**SECTION 00 9122**  
**REBID ADDENDUM NUMBER 2**

**DATE: December 1, 2016**

**RSMP Phase 2A REBID**  
**James Monroe High School**  
**RFI LOG**  
12/1/16

HMA-113 – THIRD FLOOR –AREA A HAZARDOUS MATERIALS ABATEMENT PLAN

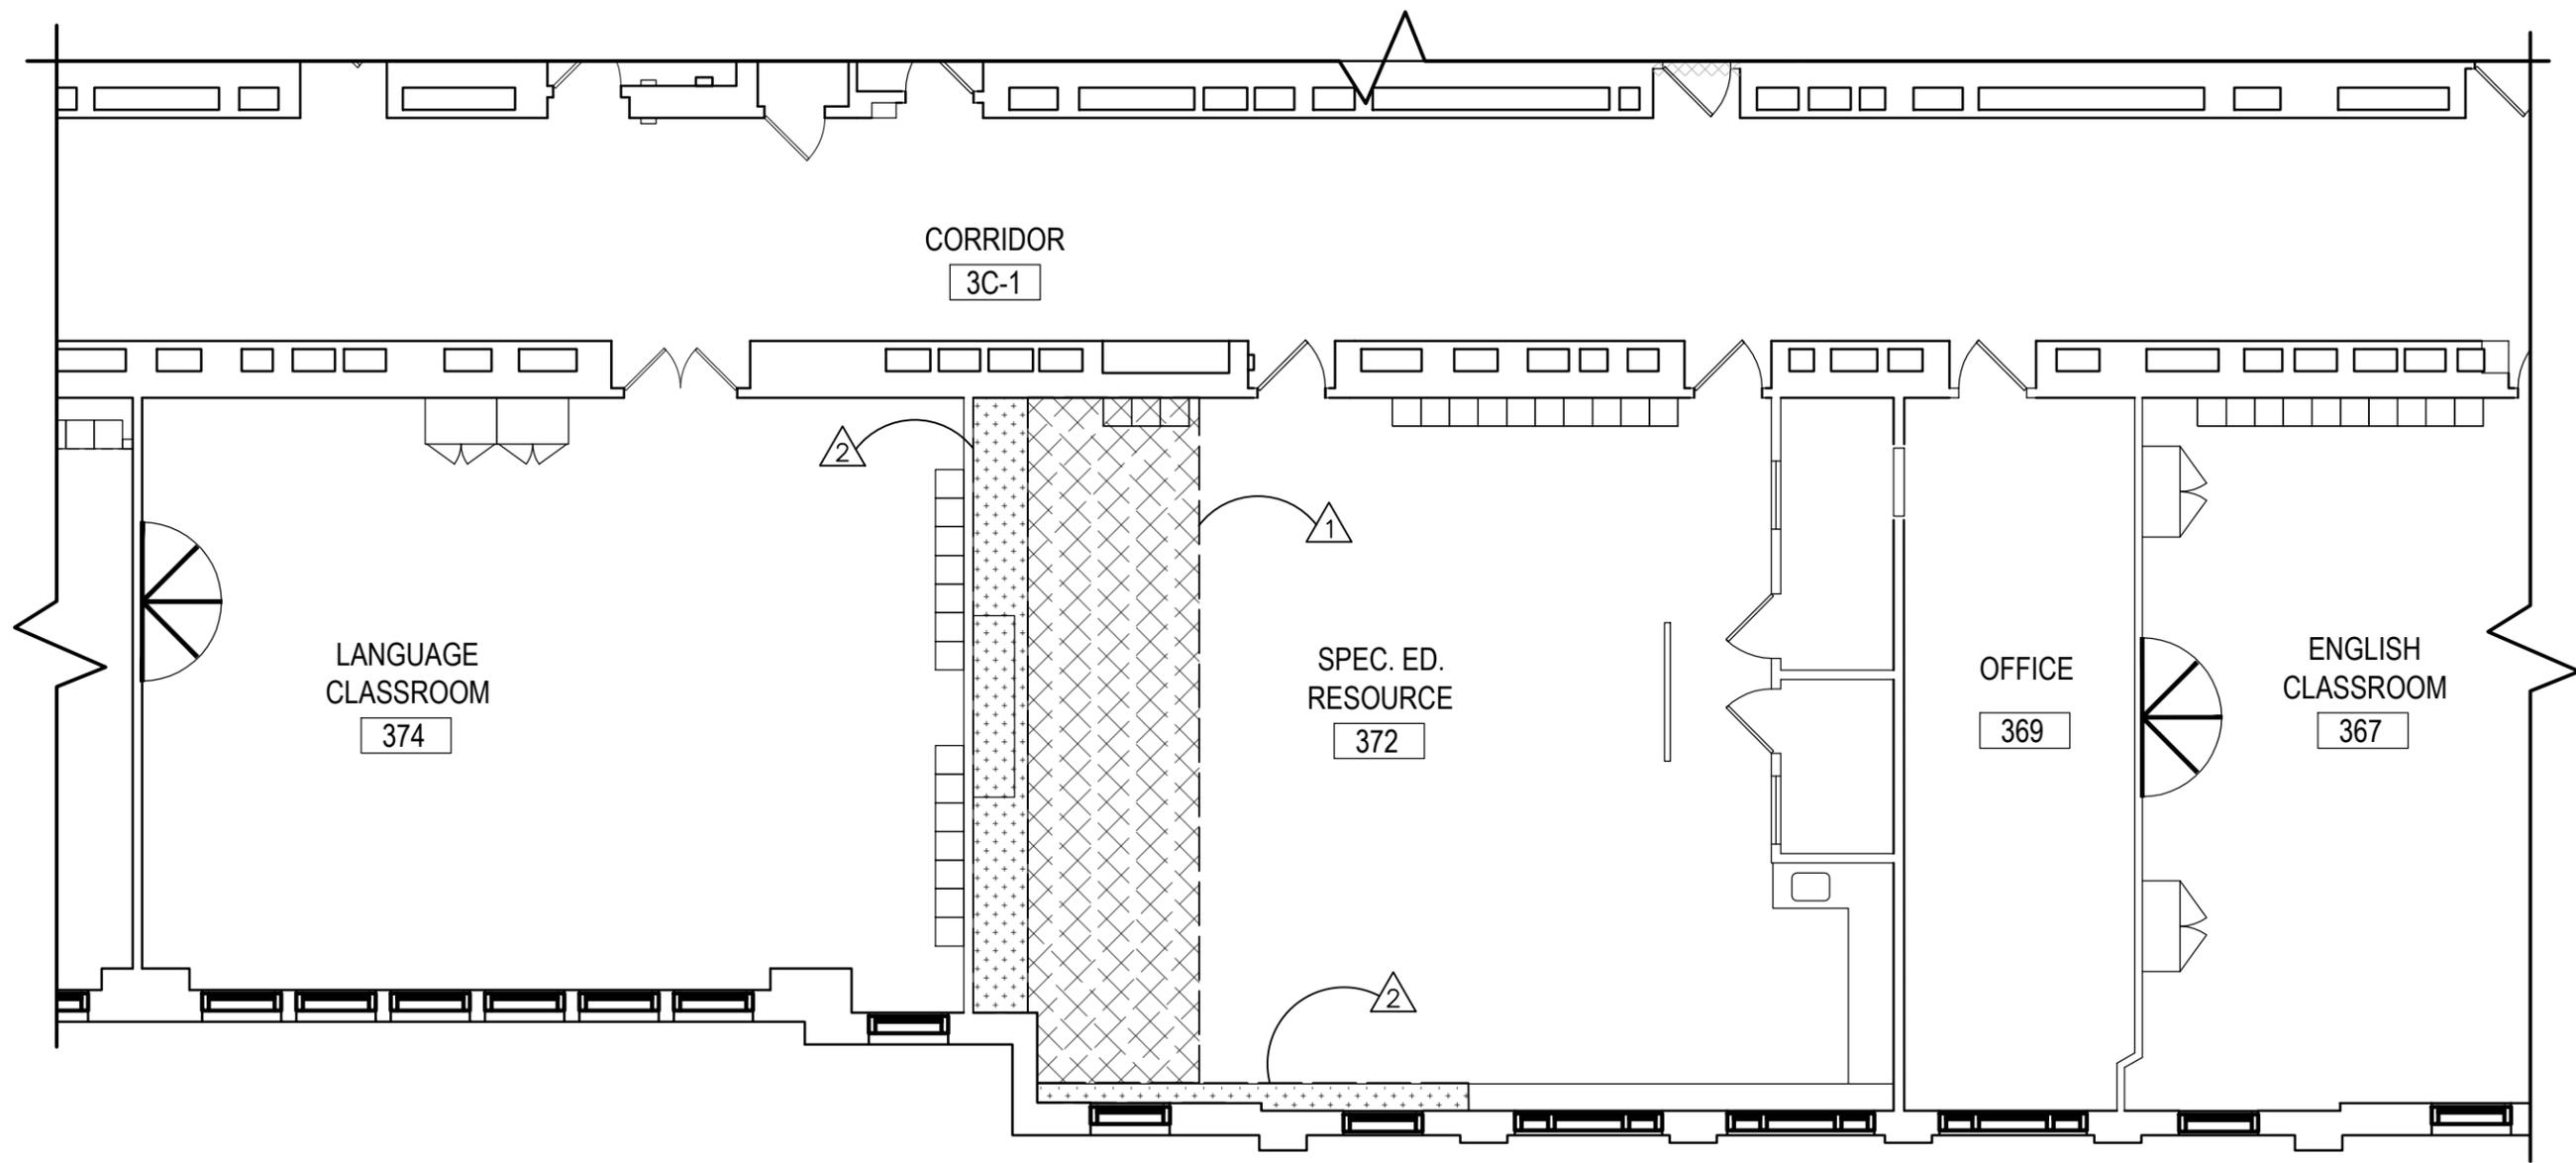
- A. Follow sketch ADD-HMA05 for additional third floor abatement work.

REMOVE AND PROPERLY DISPOSE OF ALL ASBESTOS CONTAINING FLOOR TILE. ASSOCIATED MASTIC IS NOT AN ASBESTOS CONTAINING MATERIAL. ASBESTOS CONTAINING FLOOR TILE EXISTS BENEATH THE WOOD UNDERLAY OF AN EXISTING NON-ASBESTOS CONTAINING FLOOR TILE SYSTEM. INCLUDES REMOVAL AND DISPOSAL OF ALL LAYERS.
-

REMOVE AND PROPERLY DISPOSE OF ALL EXPOSED ASBESTOS CONTAINING FLOOR TILE. ASSOCIATED MASTIC IS NOT AN ASBESTOS CONTAINING MATERIAL.

DRAWING NUMBER: ADD2-S011

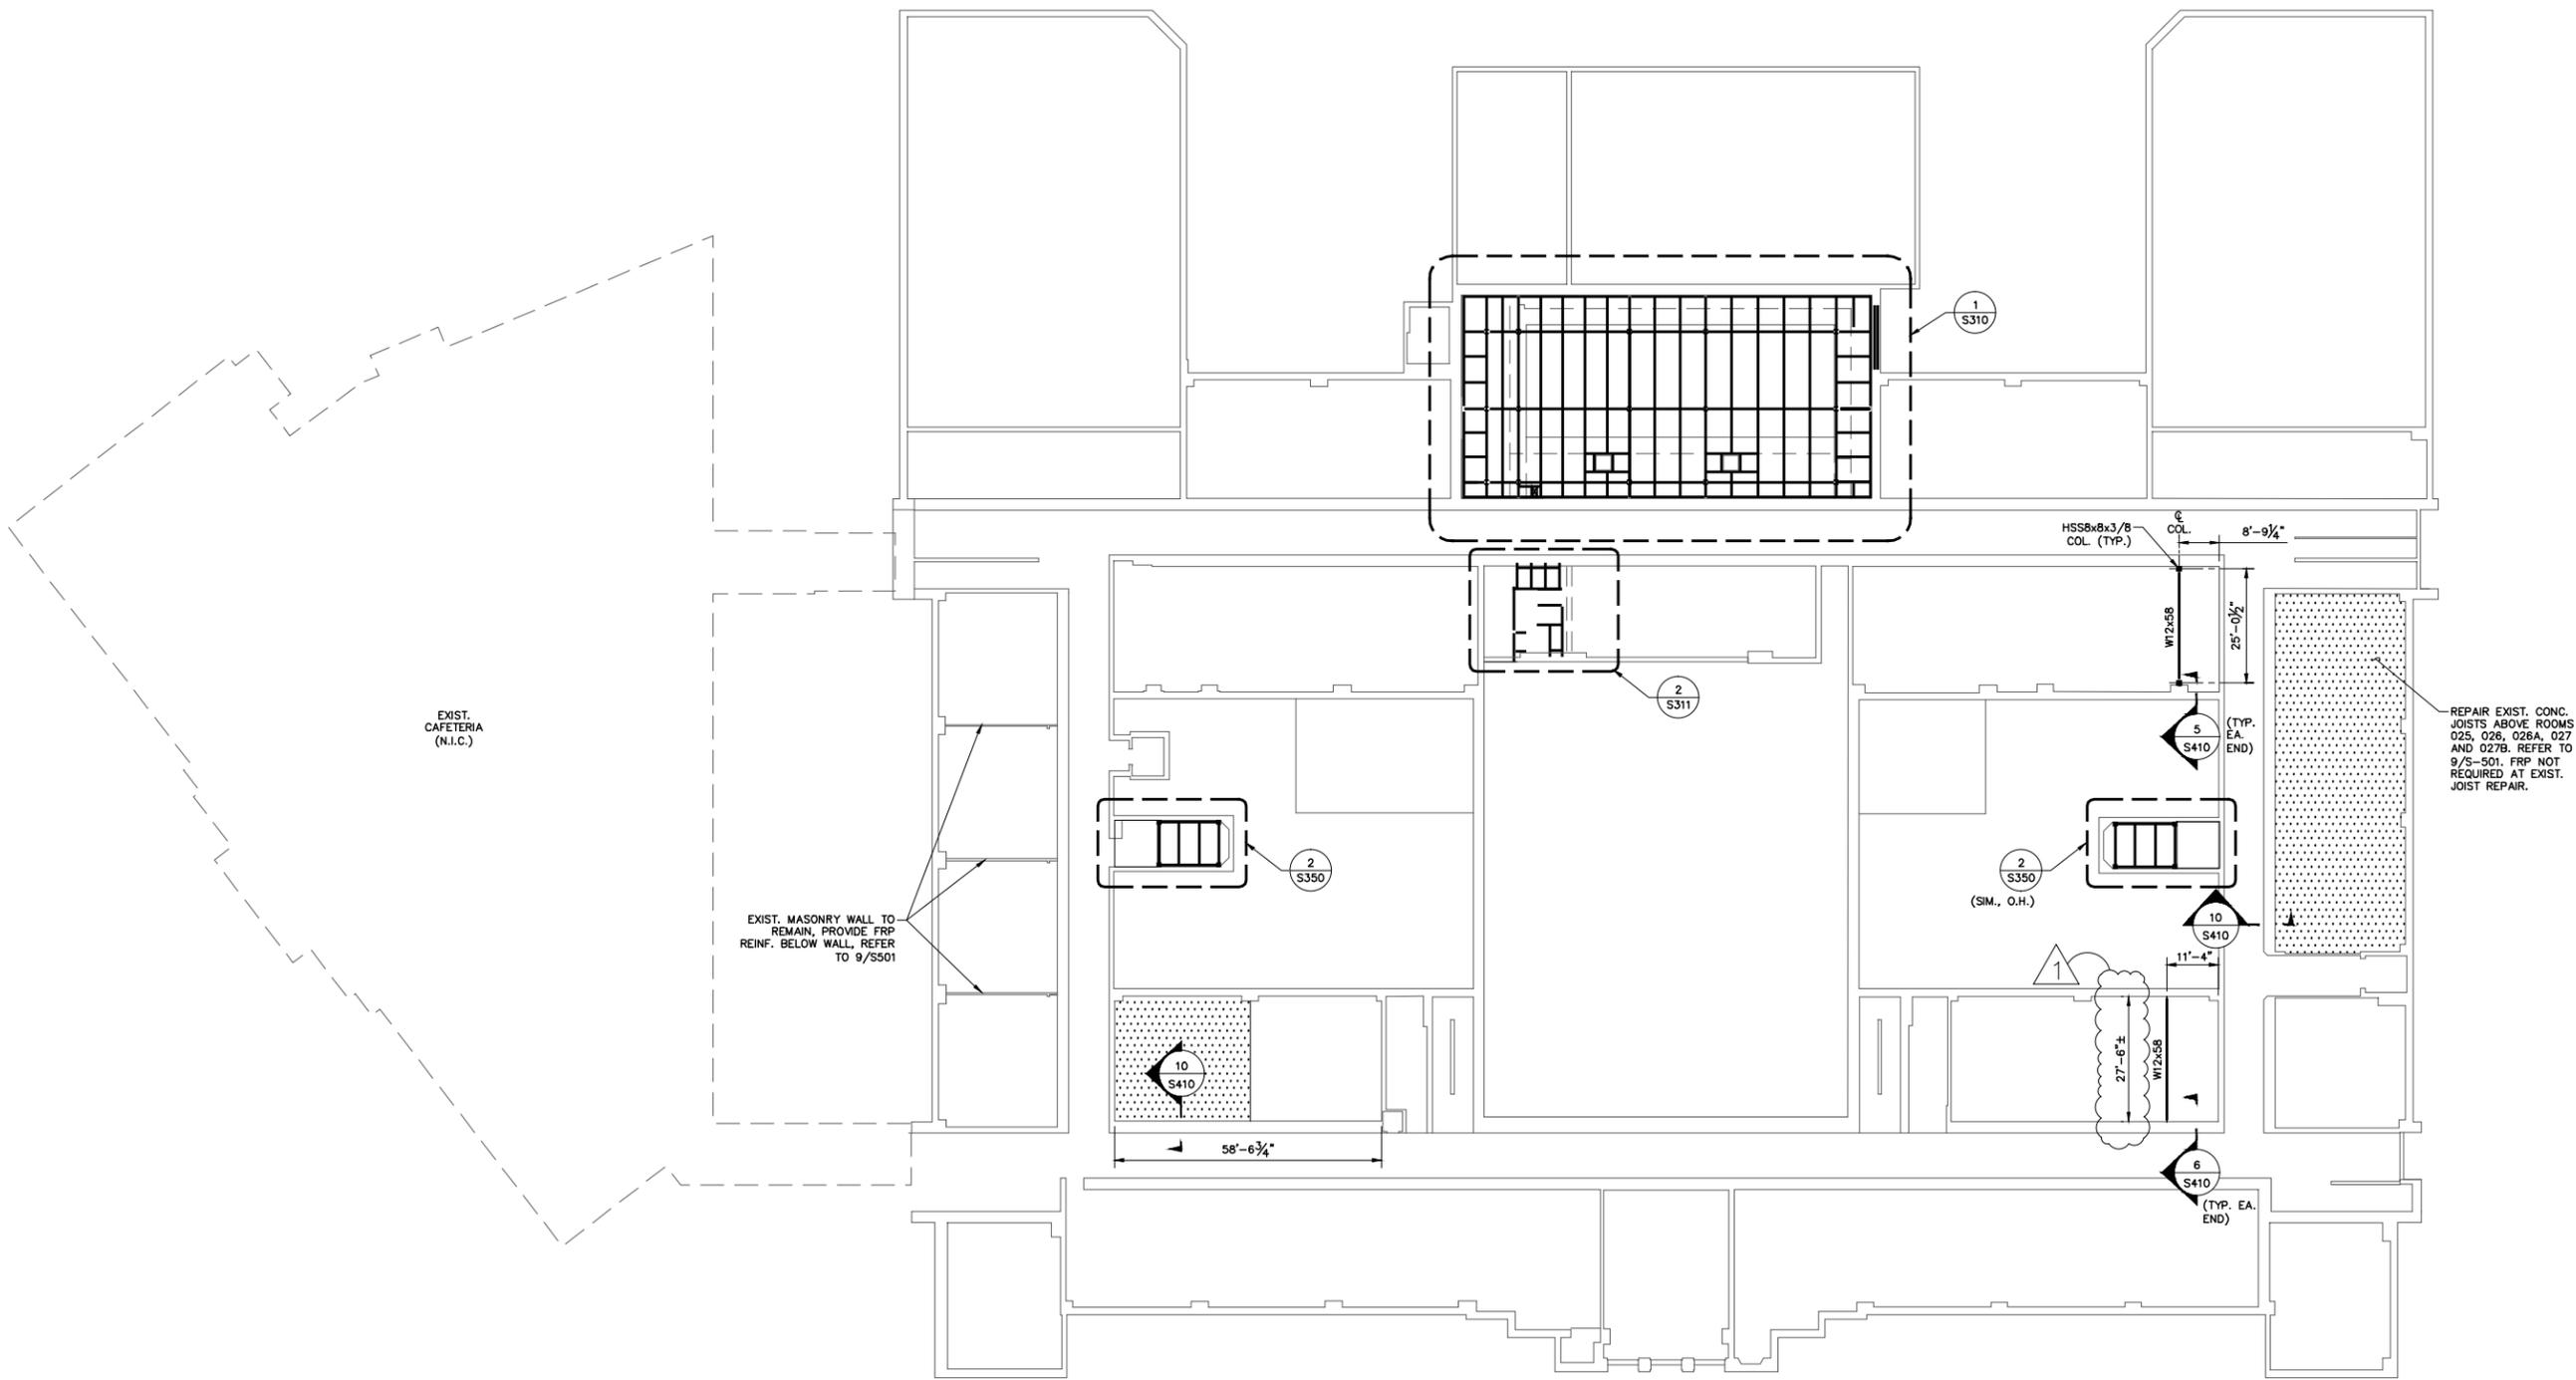
- A. Follow revisions to drawings on the following attached sketches:
- ADD2-SD100 Basement Demolition Key Plan
  - ADD2-S011 First Floor Key Plan
  - ADD2-S013 Third Floor Key Plan
  - ADD2-S200 North and South Façade Elevations
  - ADD2-S201 East and West Façade Elevations
  - ADD2-S311 Enlarged Framing Plans
  - ADD2-S400 Foundation Sections
  - ADD2-S410 Framing Sections
  - ADD2-S501 Typical Details

DRAWING REFERENCE NUMBER(S): **AS NOTED**  
DRAWING NUMBER: **ADD2-S200**

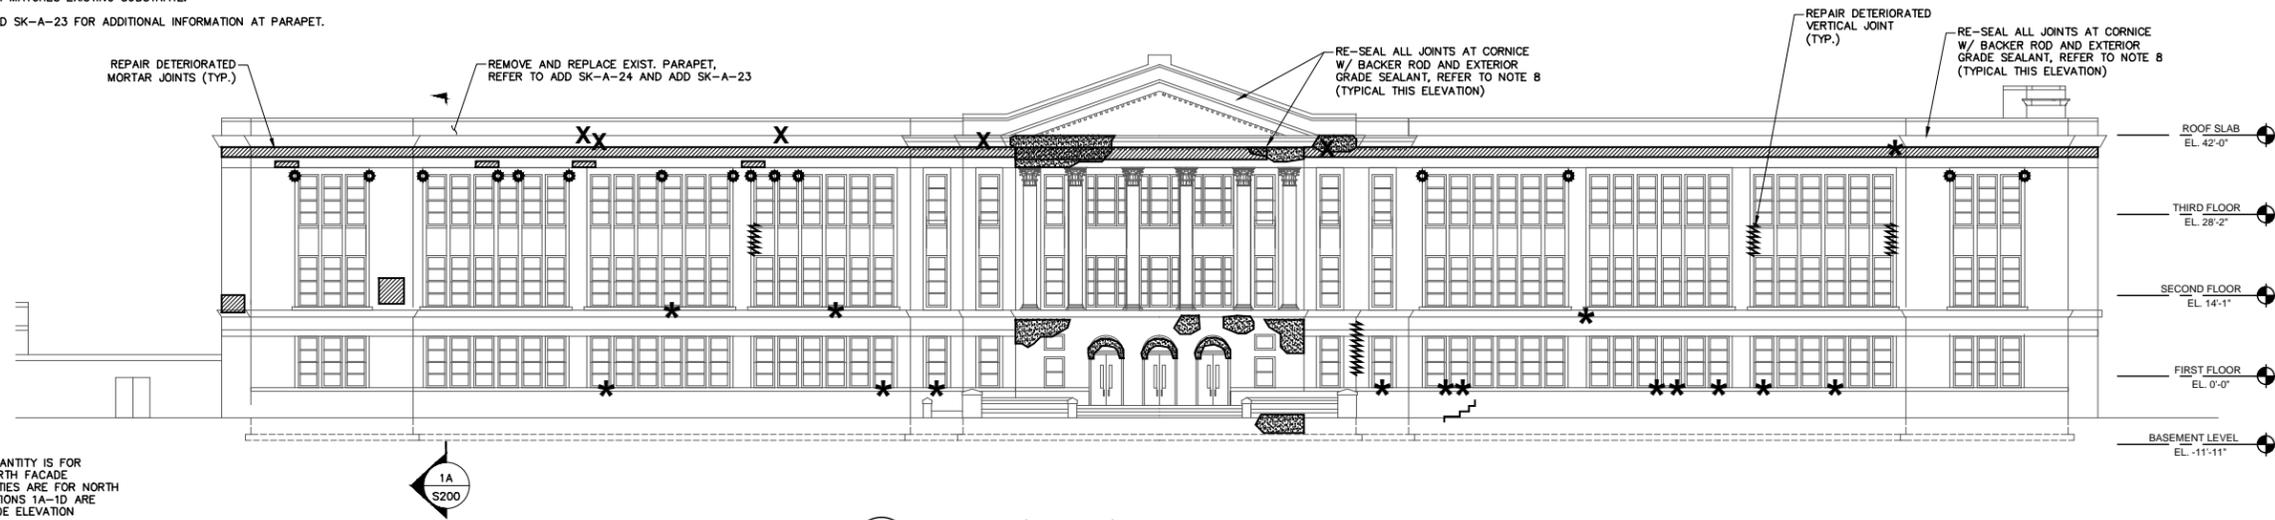
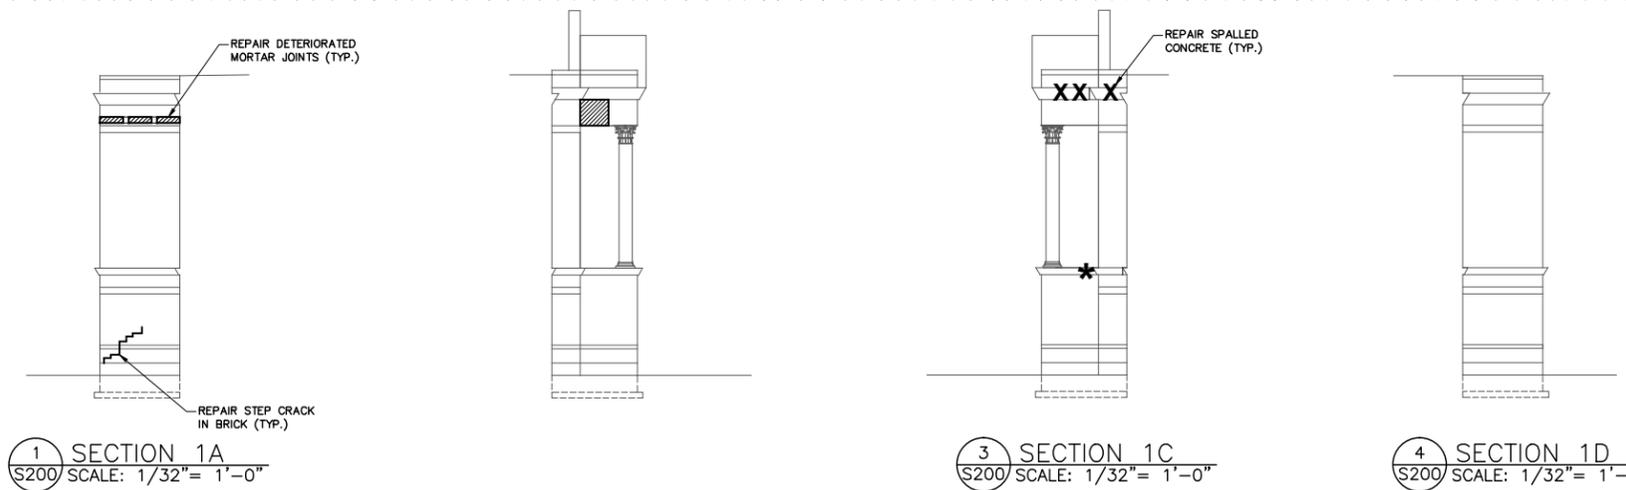
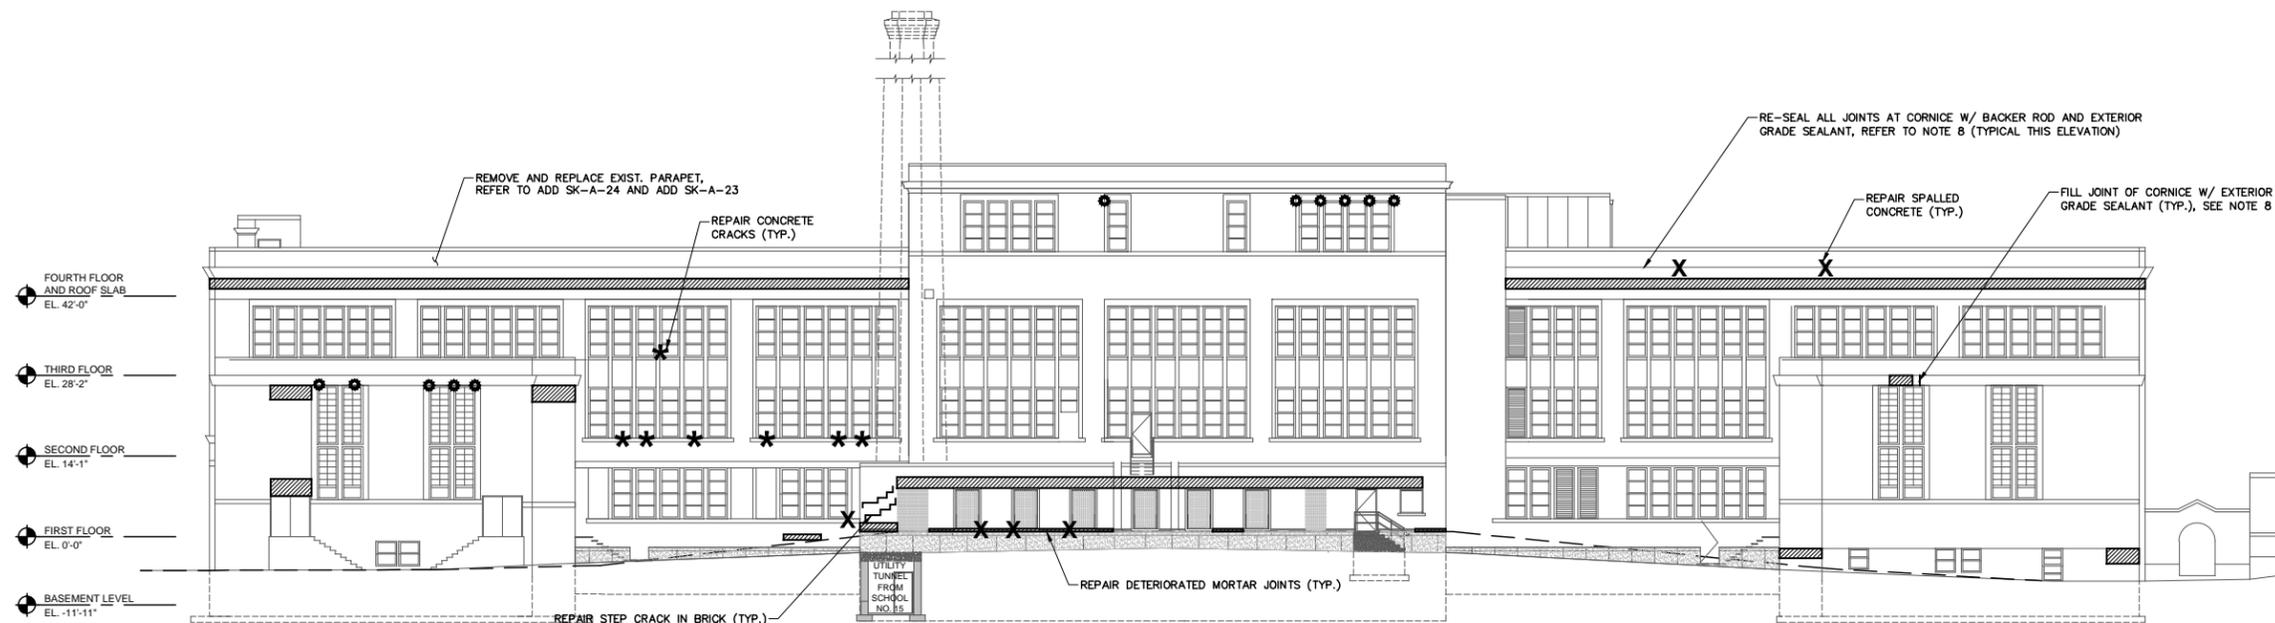
- REFER TO ADD SK-A-24 AND ADD SK-A-23 FOR ADDITIONAL INFORMATION AT PARAPET.
